Concerns with
Draft Disability (Access to Premises – Buildings) Standard

Paper used as a basis for the PDA Submission to the
Federal Parliament's Legal and Constitutional Affairs Committee

All comments in this document refer to the Draft Disability (Access to Premises – Buildings) Standard which can be downloaded from <http://www.aph.gov.au/house/committee/laca/disabilitystandards/tor.htm>

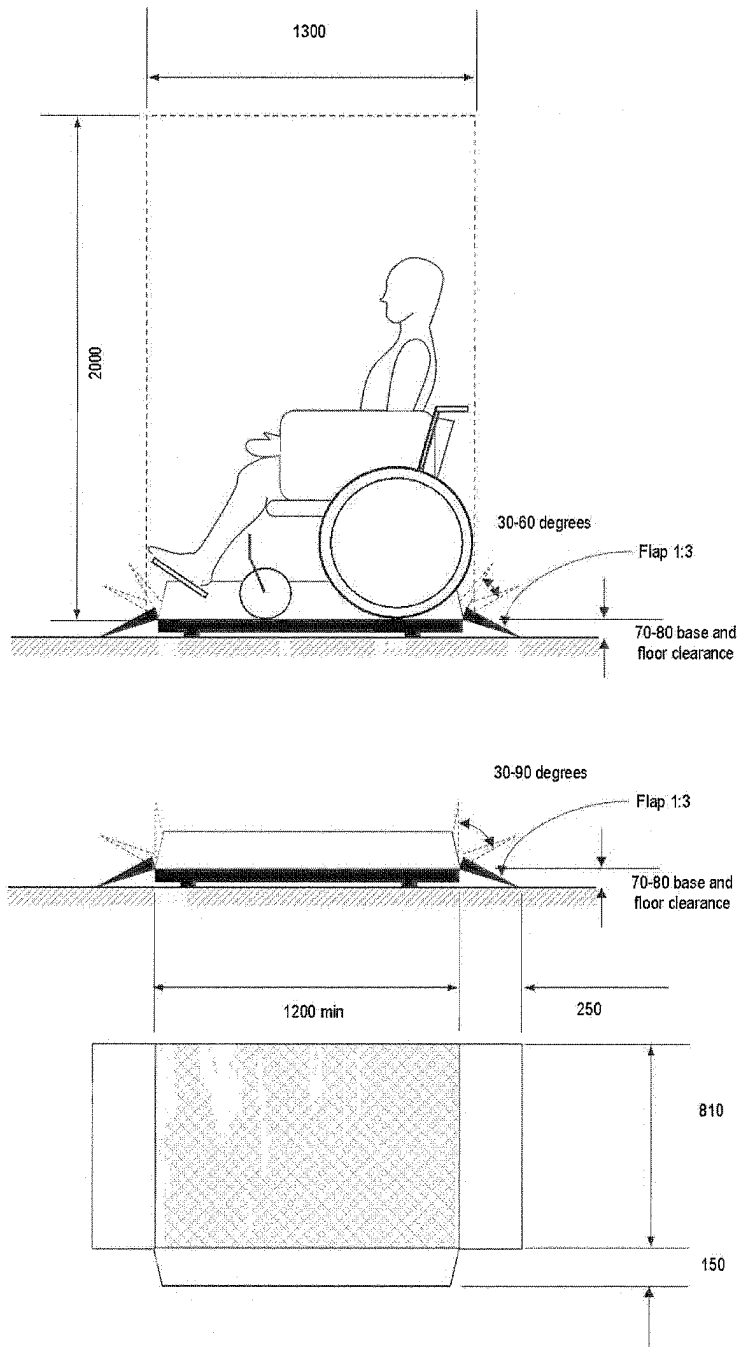
Table 1 requires the minimum platform dimensions to be 685mm wide x 1000mm long. However the draft DDA Premises Standard requires the minimum platform size for stairway lifts in public buildings to be 810mm wide x 1200mm long. It is recommended therefore that Table 1 be amended to show the platform minimum dimensions as 1200mm long and 810mm wide. The Note to Table 1 states that length is measured horizontally in the direction of travel between the safety flaps in the elevated position or the sensitive edges in the non-actuated position, whichever applies. The position at which length is measured is not clear to all readers and it is recommended that a Figure be provided to clarify the requirement.

- It is recommended therefore that Table 1 be amended to show the platform minimum dimensions as 1200mm long and 810mm wide.
- It is recommended that a Figure be provided in association with Table 1 to clarify the position at which platform length is measured.

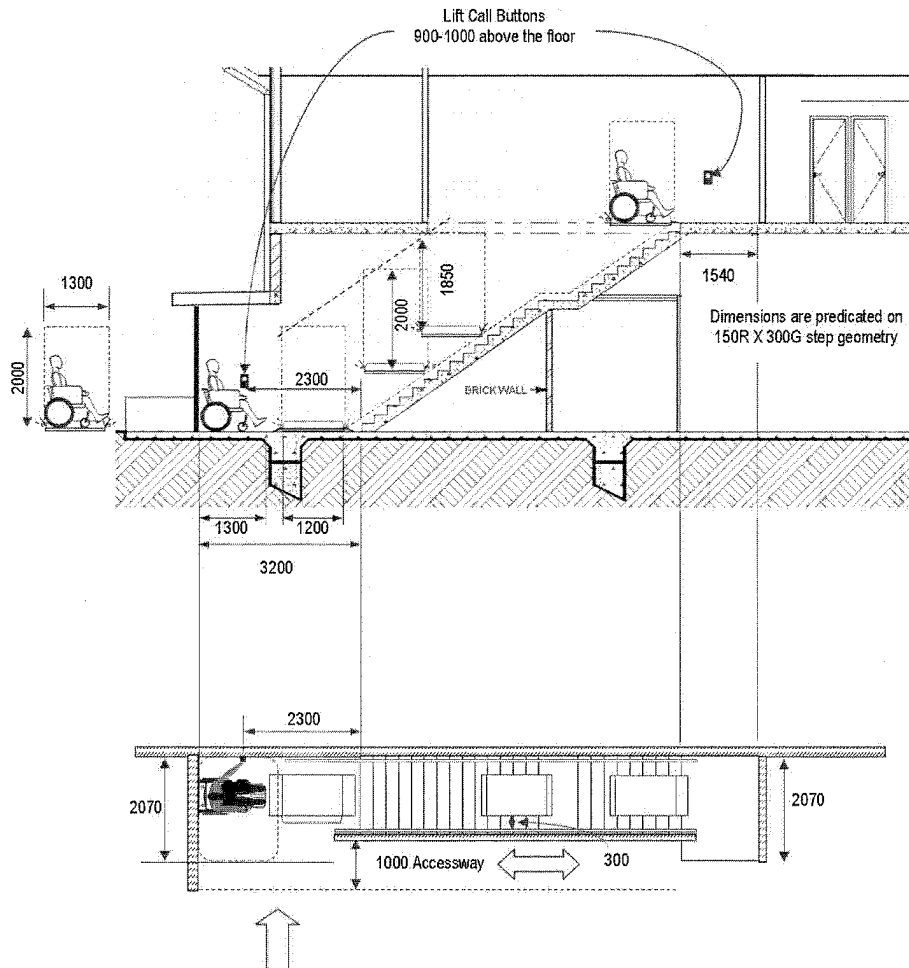
While Clause 14 refers to an end person clearance of 300mm, this clearance does not address the necessary wheelchair circulation space as shown in the figure below required for the bottom landing and the top landing. Access to the platform shall be by end approach only.

- It is recommended that a sub-Clause be added to Clause 14 requiring wheelchair circulation space as shown in the figure below at the bottom

landing and at the top landing for stairway lifts in public buildings.

- It is recommended that a sub-Clause be added to Clause 14 requiring access to the platform to be by end approach only for stairway lifts in public buildings as shown in the figure below.

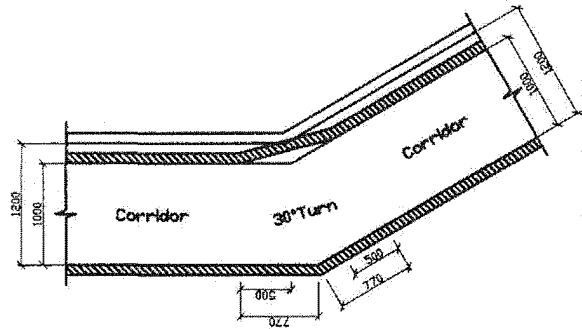
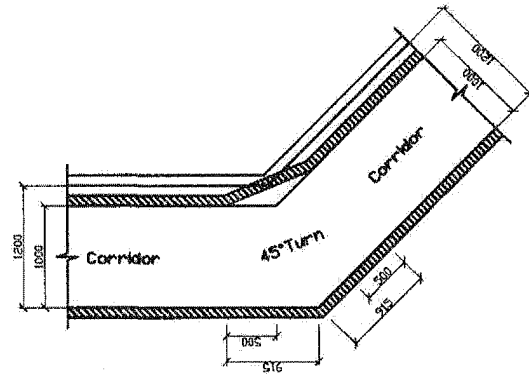
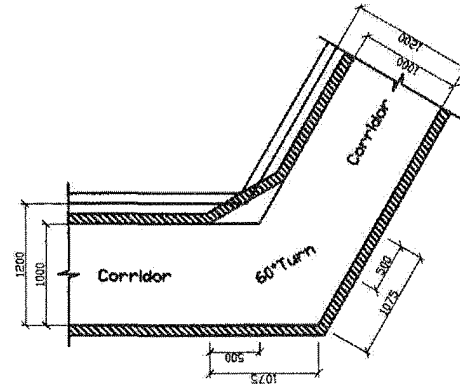
Corridor Landing
90° Turn
Passing not possible

Corridor Landing
30° Turn possible
Passing not possible

Corridor Landing
45° Turn possible
Passing not possible

Corridor Landing
60° Turn possible
Passing not possible

FIGURE 4
REDUCED ACCESS RESULTING FROM INTERFACING CORRIDOR WIDTH FROM ASI428 PART 1-2001 WITH DOOR CIRCULATION SPACE TO ASI428 PART 2-1992

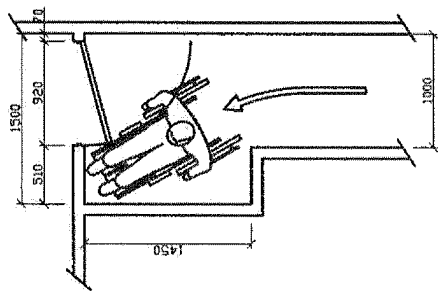
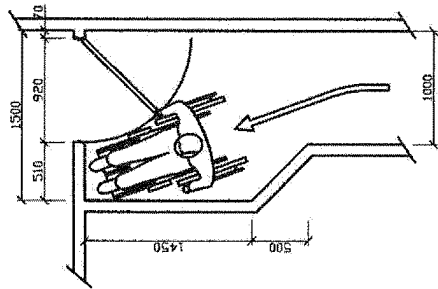
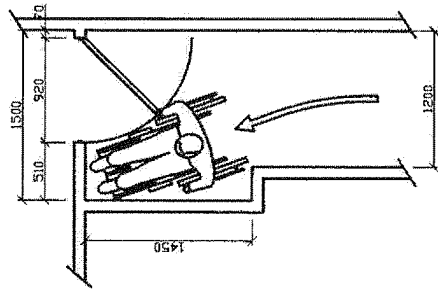
FIGURE 4(a)
Proposed Access to Doorway by Interfacing Corridor Width from ASI428 Part 1-2001 with Door Circulation Space from ASI428 Part 2-1992. This layout would not be accessible to many wheelchair users and would waste the additional space.

FIGURE 4(b)
Corrected Requirement Suggested for ASI428 Part 1-20XX. This layout would be expensive to construct and would encroach further on the adjoining room space.

FIGURE 4(c)
Access to Doorway by Providing Corridor Width and Door Circulation Space from ASI428 Part 2-1992. This layout would be inexpensive to construct and would encroach little on the adjoining room space.

FIGURE 2:
Minimum width of Corridor
AS1428.1-2001

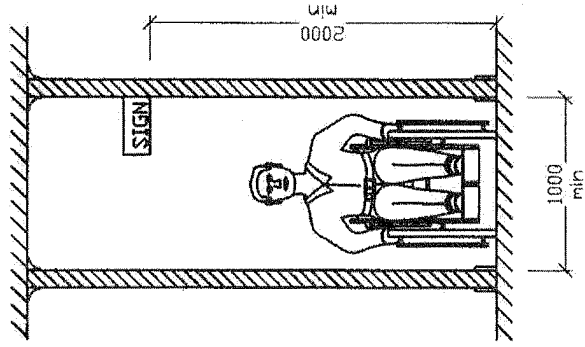
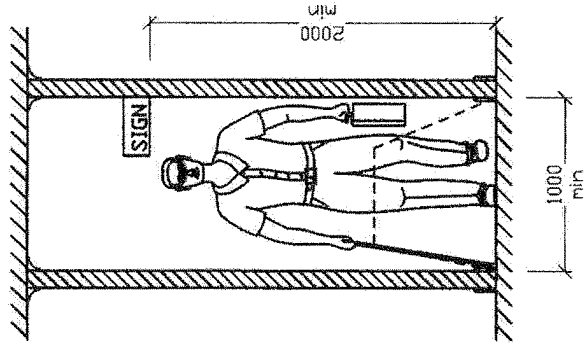
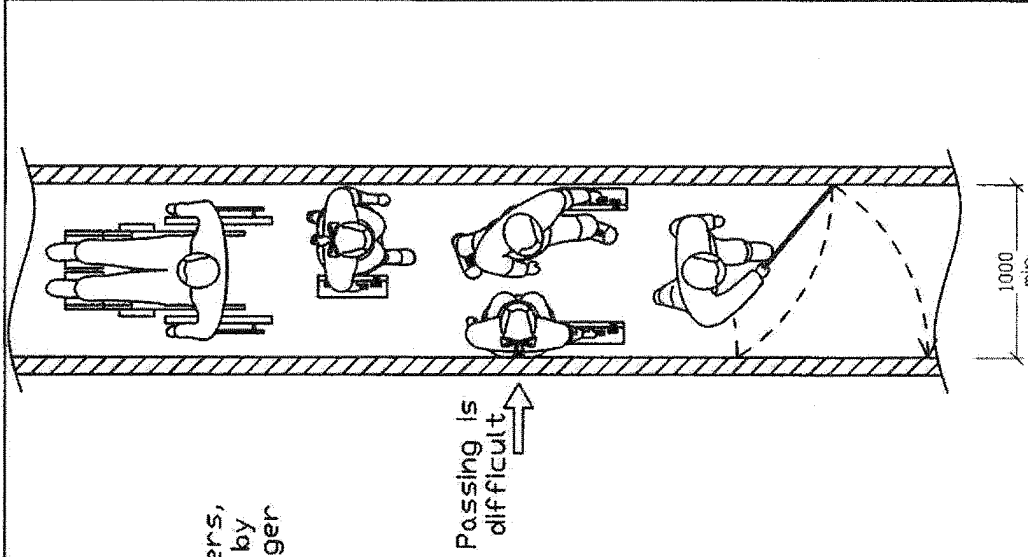
While a 1000 wide corridor may be accessible by most users, it clearly does not permit passing of wheelchair users by ambulant persons. Further, it creates difficulty for larger ambulant persons to pass each other.

The 1000mm corridors as in AS1428 part 1 should be 1200mm to allow for safe and comfortable travel and passing and to bring this into line with other changes to AS1428. part 1 which cater for 90% of wheelchair users;

FIGURE 1:
Minimum width of Corridor
AS1428.2-1992

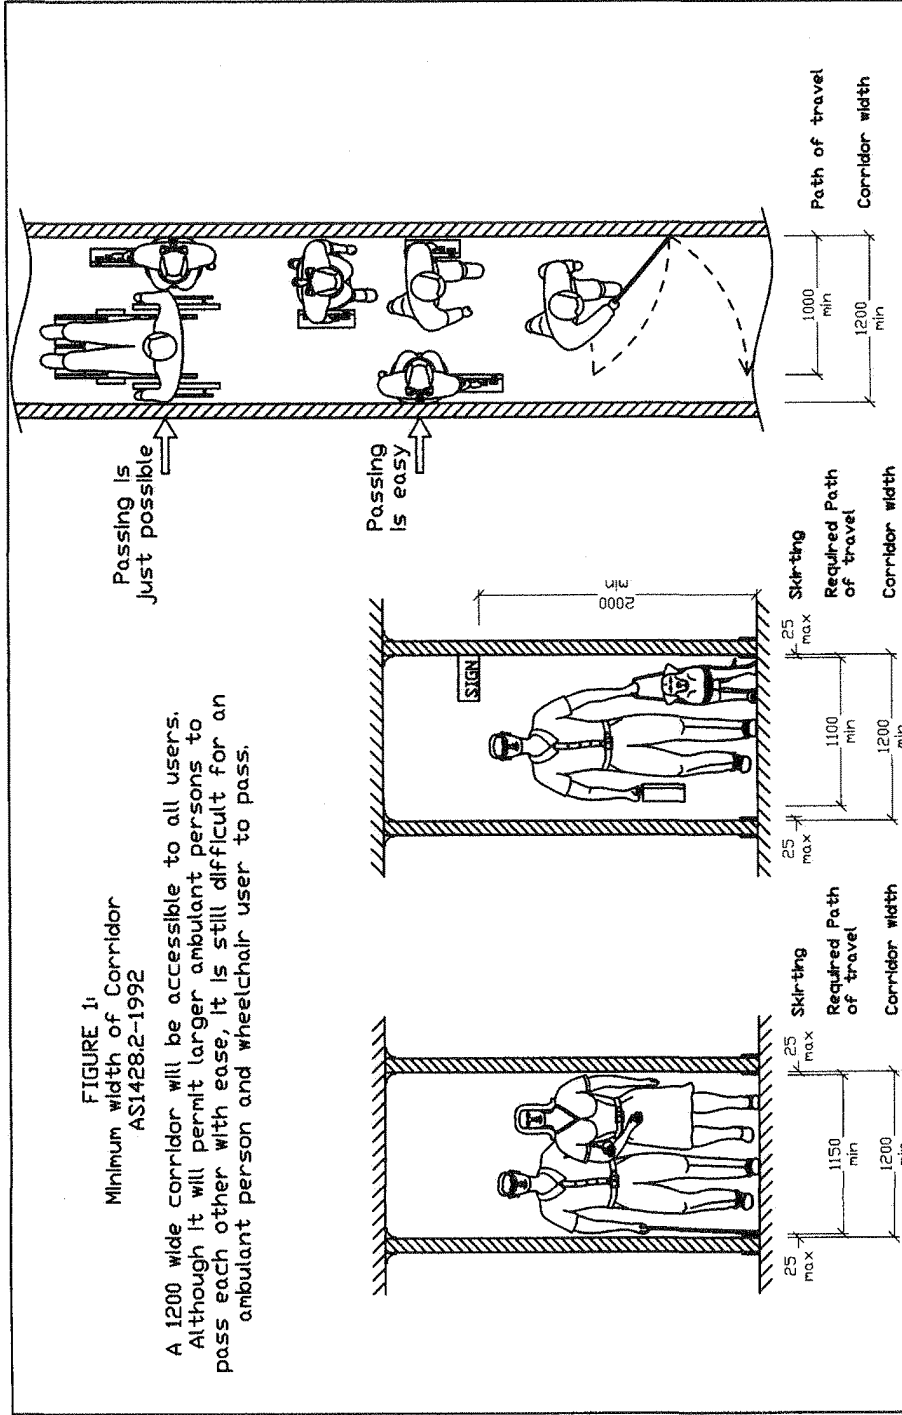
A 1200 wide corridor will be accessible to all users.
Although it will permit larger ambulant persons to pass each other with ease, it is still difficult for an ambulant person and wheelchair user to pass.
